City of Surrey
ADDITIONAL PLANNING COMMENTS

File: 7915-0118-00

Planning Report Date: February 24, 2020

RESPONSE FOR ADP COMMENTS (FILE NO. : 7915-0118-00)

Drawing Title:
**BUILDING 1
 ELEVATIONS**

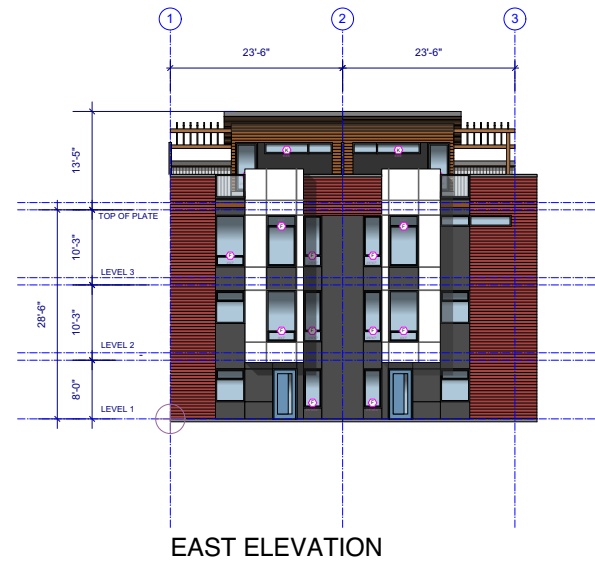
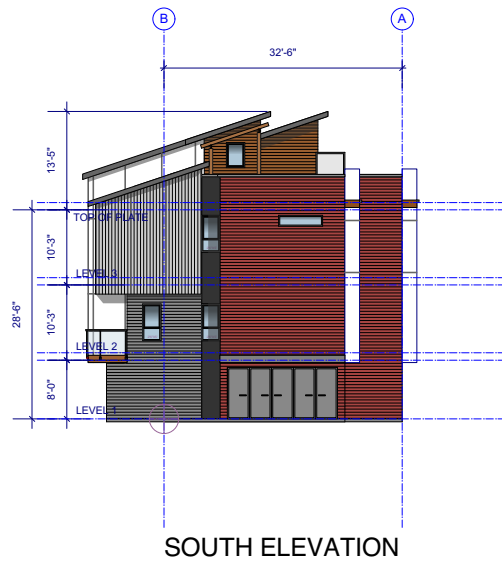
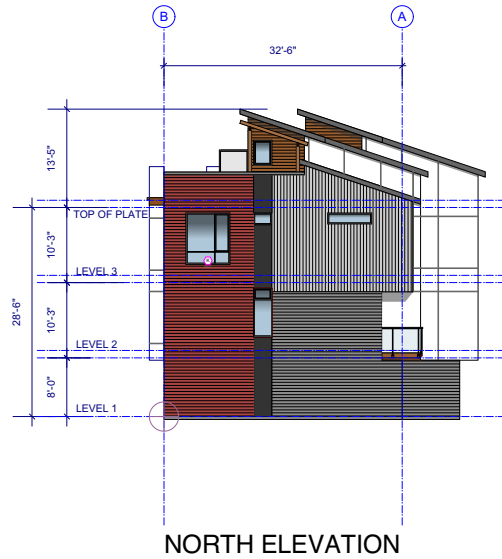
- Further to the height reduction, the east building elevation facing 172 Street has been simplified with more modest roof forms, similar to single family forms in the surrounding neighbourhood. With the previous design, the gable ends of multiple shed roof peaks drew attention to the building height. The revised roof forms are simple open gable ends, with shorter peaks, and are fewer in number, thereby drawing less attention to the roofline. The overall appearance of height is scaled down with this redesign of the roofline.

- The elevation drawing now shows the proposed interface with the existing townhouse development to the south at 127 – 172 Street, illustrating a 16.5 metre separation between the buildings, as well as minimal difference in building height.

-
- In addition to the reduction in height, the mixed-use building was redesigned with more modest roof forms, similar to single family forms in the surrounding neighbourhood. The overall building appearance and massing is scaled down with this redesign of the roofline.

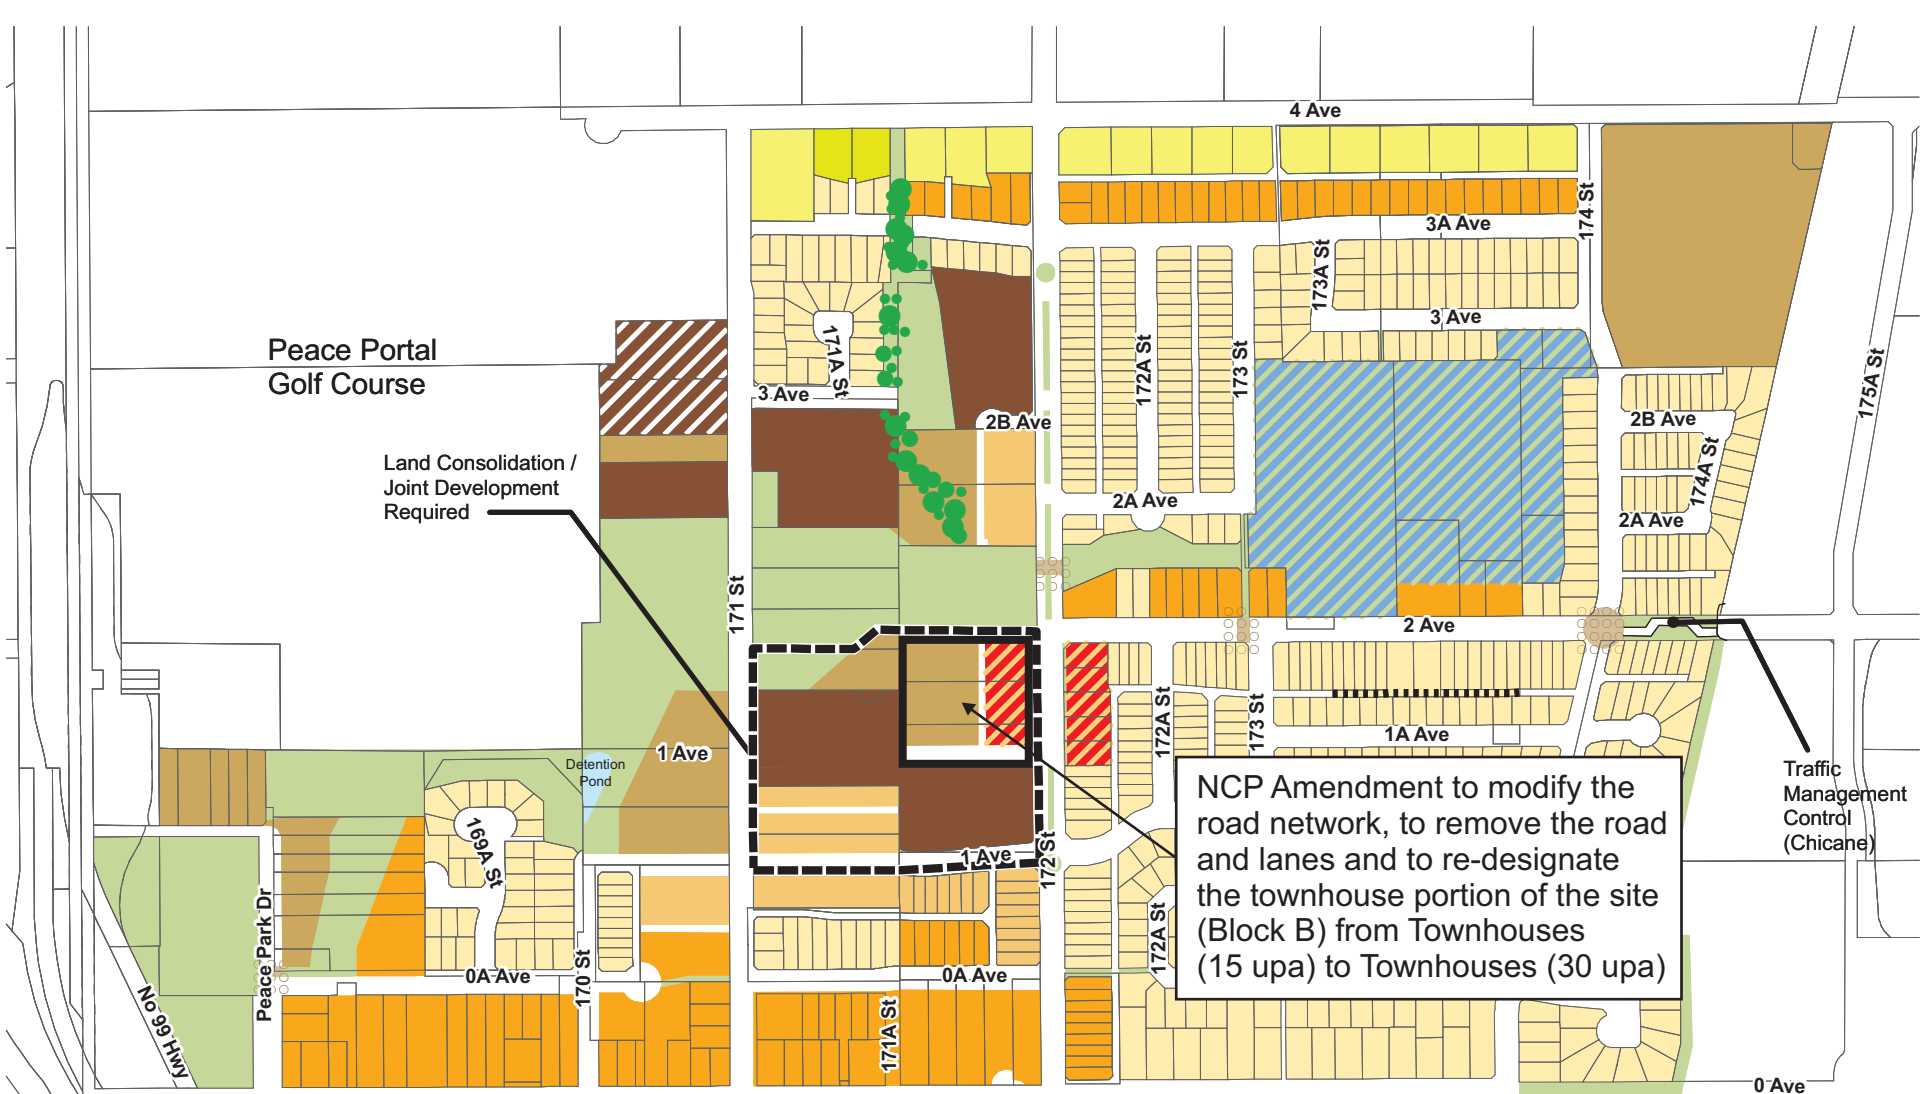
3. Recommend that the amenity restrooms and showers be accessible and larger with a fold-down bench.

Implemented. Please see A103.
